Fireplace geometry / material coordination

5309 Meadow Chase · VIS-03 · 27 September 2026

VIS-03 — geometry/material coordination revision based on latest fireplace/hearth dimensions and confirmed Durham Hickory II flooring; supersedes VIS-02 for design geometry while retaining VIS-02 room/context reference.

02 / Angled room view

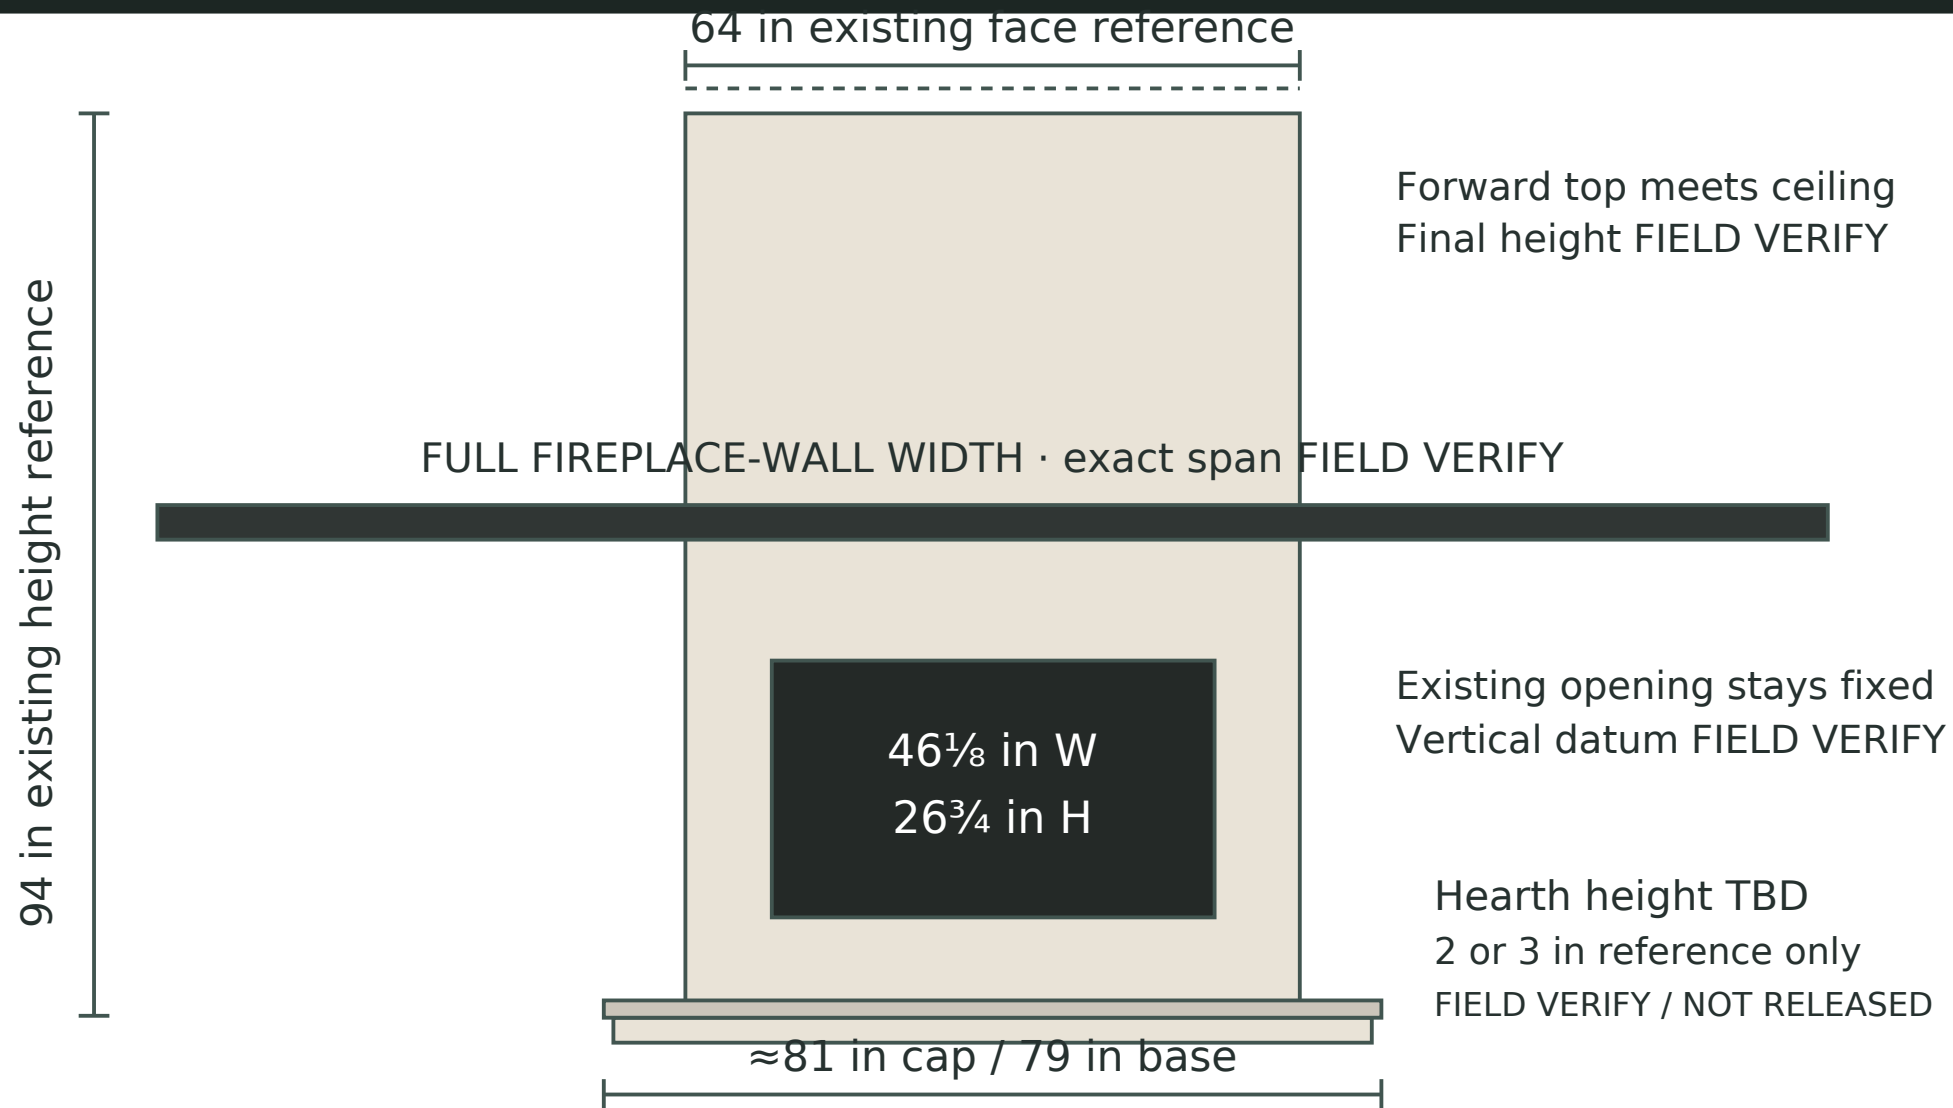
Photorealistic concept using VIS-02 room/context. Mantel thickness/elevation and hearth height are illustrative; not fabrication dimensions. Hearth height FIELD VERIFY / NOT RELEASED.

04 / SIDE-PROFILE COORDINATION

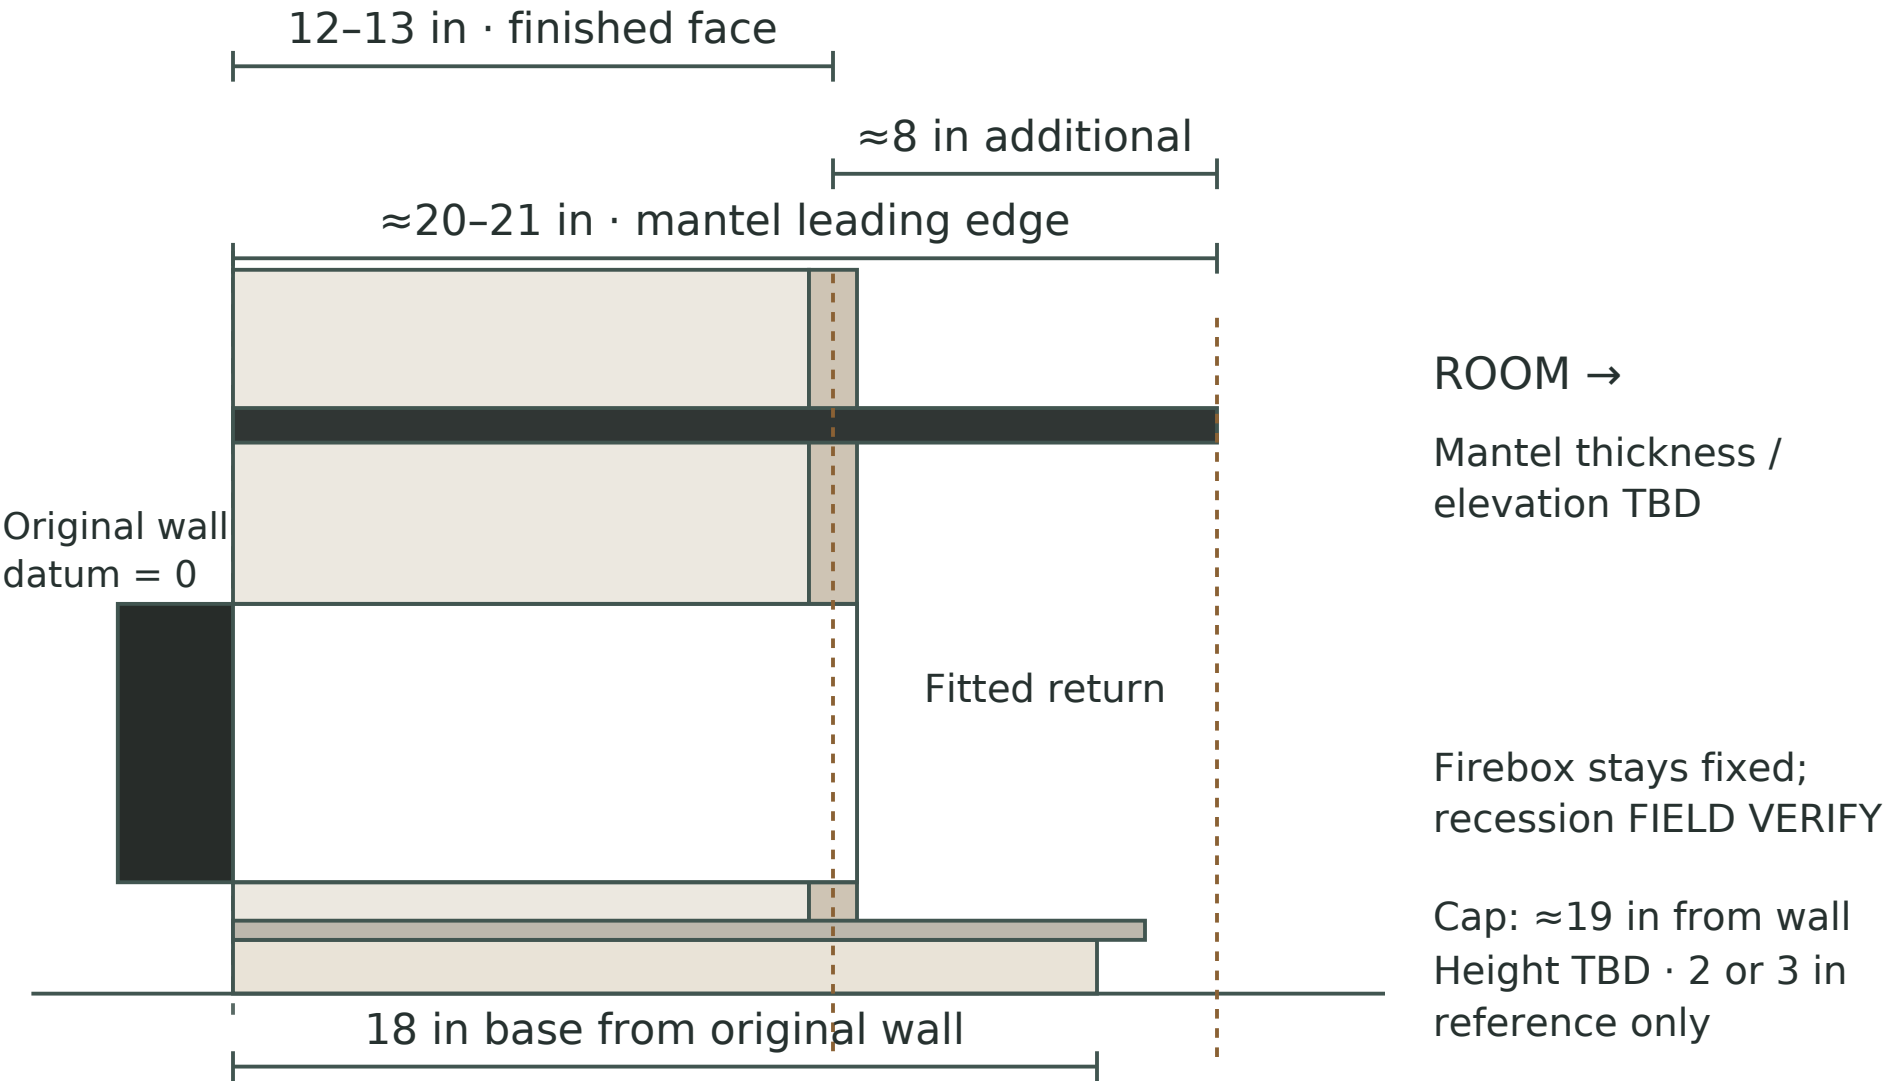
OWNER/GC DIRECTION · depth datum is ORIGINAL WALL, not finished stone · vertical layout schematic

Cap extends ≈6-7 in beyond stone; mantel projects ≈1-2 in beyond cap (derived, field verify).
12-13 in includes framing/substrate/stone. Component thicknesses and required air spaces are NOT assigned.
Hearth height FIELD VERIFY / NOT RELEASED. Verify ceiling rise/scribe and exact existing firebox datum.

05 / HEARTH PLAN DETAIL

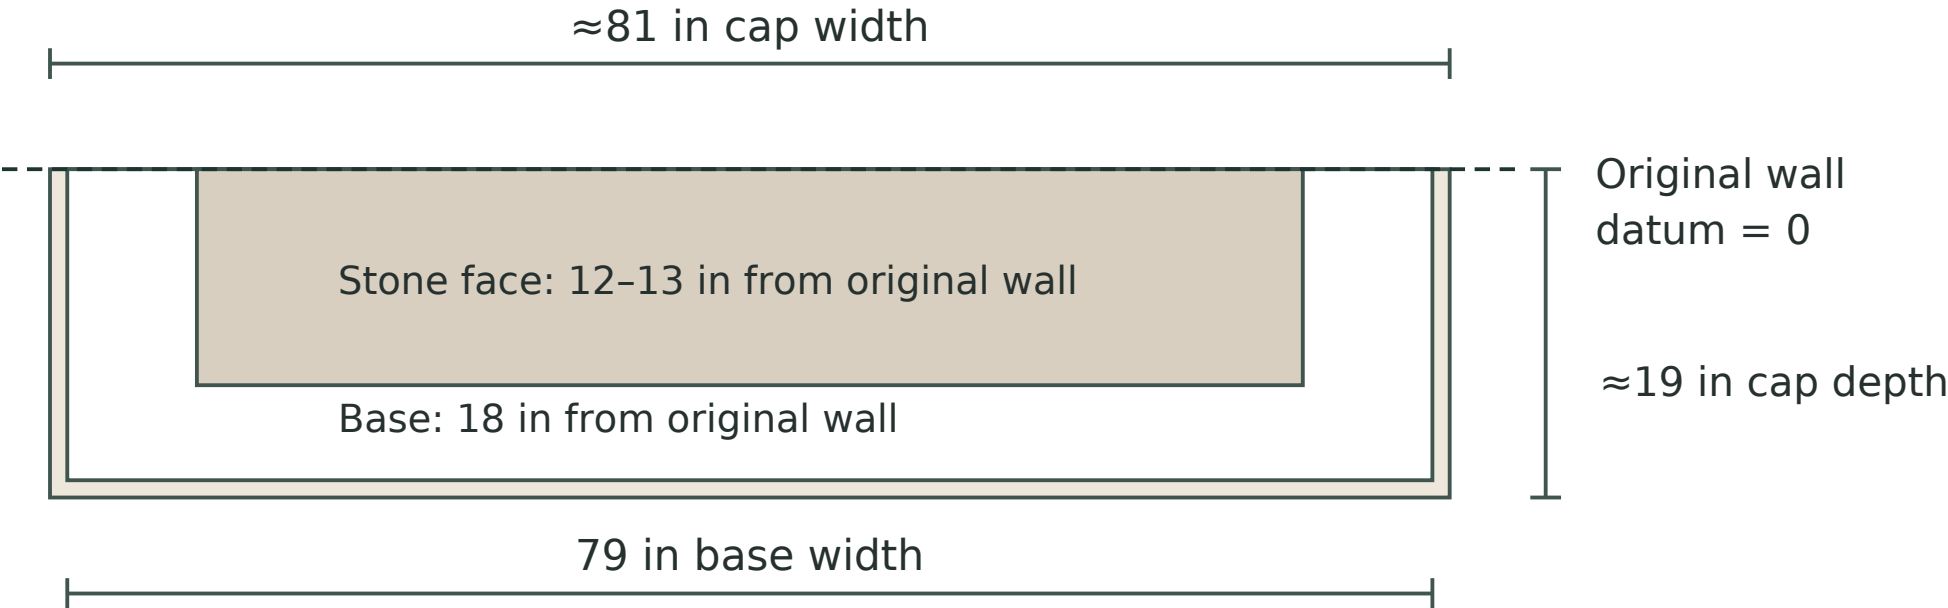
OWNER/GC DIRECTION · base 79 × 18 in; cap approximately 81 × 19 in

≈1 in cap overhang at each side and front; rear edges share original wall datum.

PLAN VIEW · height TBD; 2 or 3 in coordination reference only.

Hearth cap material, thickness, edge treatment, support and joints FIELD VERIFY.

The 18 / 19 in depths start at the original wall, so exposed hearth is reduced by the new face.
Cap exposed beyond stone ≈6-7 in; base exposed beyond stone ≈5-6 in (derived only).
FIELD VERIFY / NOT RELEASED: height, finished floor datum, appliance hearth requirements and circulation.

06 / FIREBOX-RETURN PLAN DETAIL

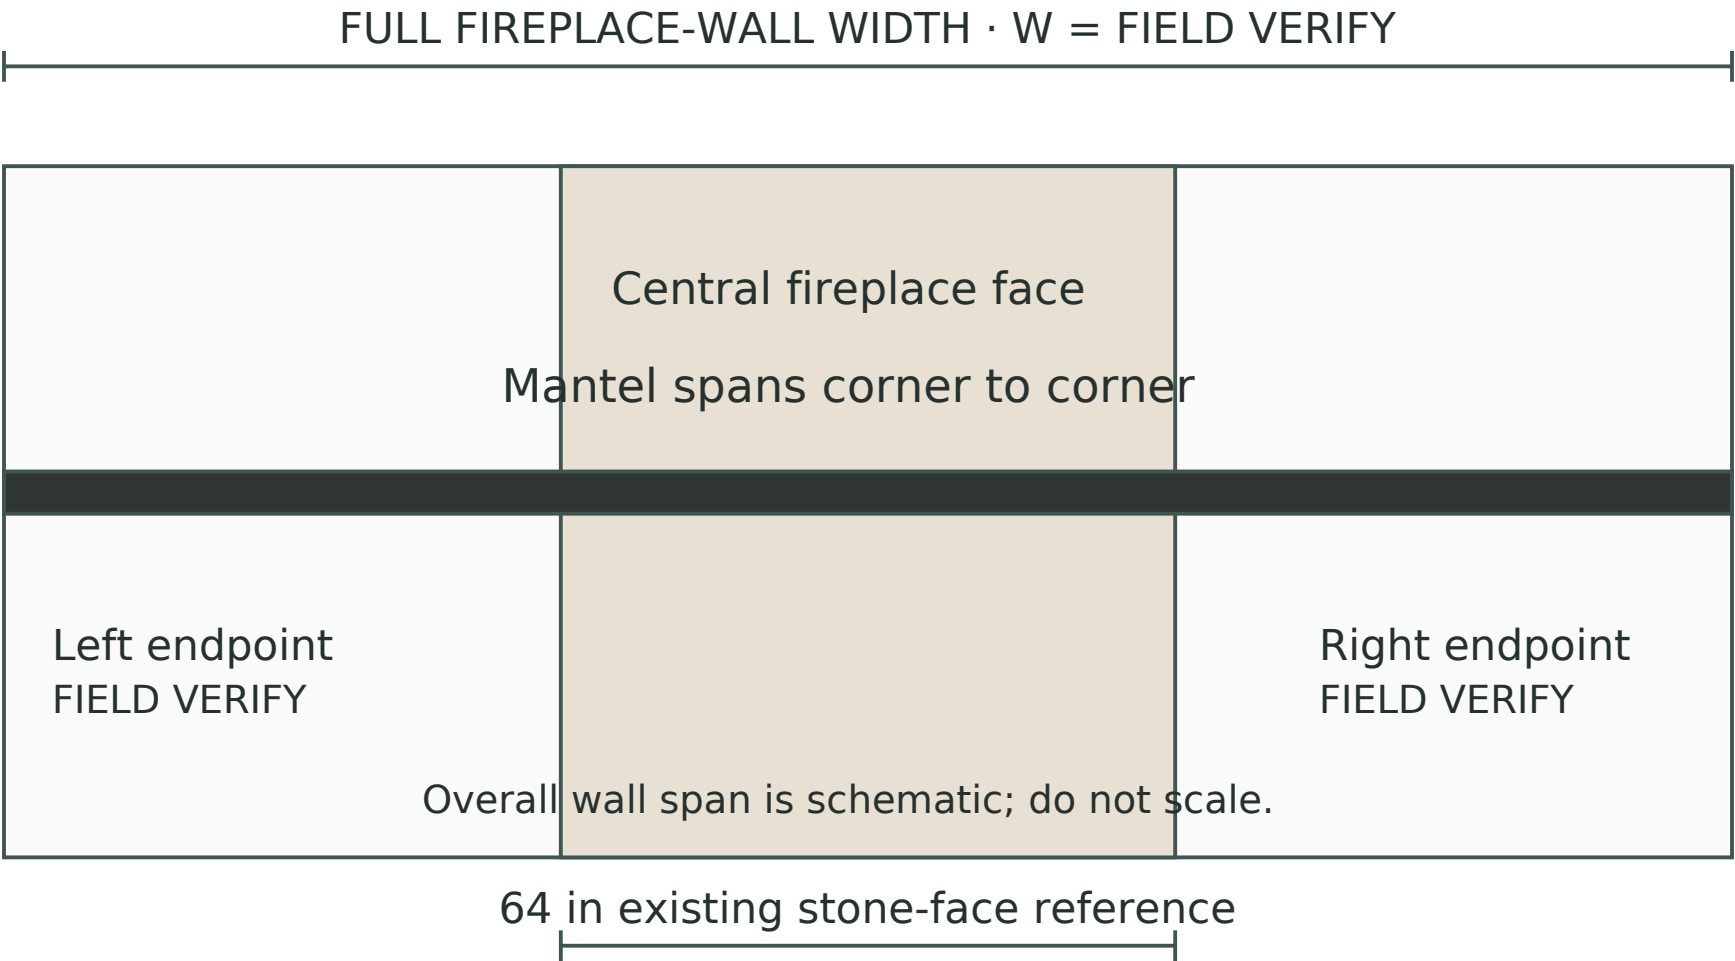
Conceptual fitted/wrapped return · NOT a firebox-extension or fabrication detail

Original wall reference · exact factory-face offset FIELD VERIFY

Finished stone face 12-13 in from original wall

Return depth = actual distance to retained factory face · TBD

Confirm permissible facing overlap, noncombustible zones, movement joints and edge termination.
Do not cover louvers, glass/door removal, convection openings, gas shutoff or lower service access.
46¹/₈ × 26³/₄ in is the recorded opening; remeasure finished clear opening after allowable transitions.
